Dublin Cycling Campaign PO Box 10295 Dublin 6w info@dublincycling.ie www.dublincycling.ie 2011- January 18th

Dublin City Council Cycle Forum

Re: Schedule of dangerous places for cyclists in Dublin. The cyclists' view

D'Olier Street on to College Street (including junctions with Fleet Street / Townsend, and curve around to the junction with Pearse Street

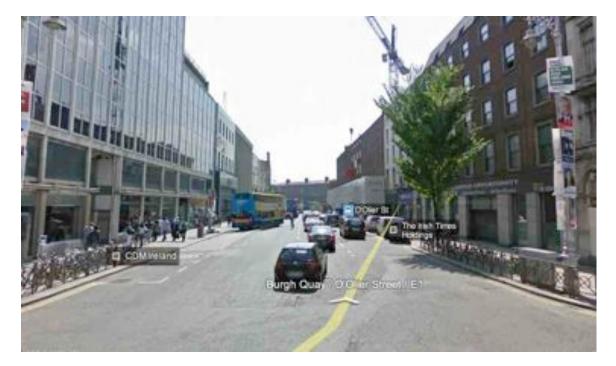
The whole multi-lane one-way system around Trinity College/Pearse Street/D'Olier Street/Westmoreland Street is threatening.

D'Olier Street heading south from O'Connell St: lanes disappear, no visible road markings, buses dive-bombing the left hand lanes (especially at rushhour), no cycle lanes at all and traffic is forced to merge from 4 lanes to possibly - three? (it's pretty hard to tell). Also zero options for bikes coming around college green: no cycle lanes anywhere!

Turning from D'Olier Street onto College Street by Doyle's pub is definitely one of them. If you're where you should be on the left hand lane, there's always a string of busses pulling in or merging back out by Trinity and although they try their hardest to accommodate bikes, the sheer flow of traffic can make it a very hairy situation. Add to that the taxis pulling in/out from the same location and from the lay by just opposite Thomas Moore statue and you're lucky to get as far as College Green without having to avoid/brake from something or someone.
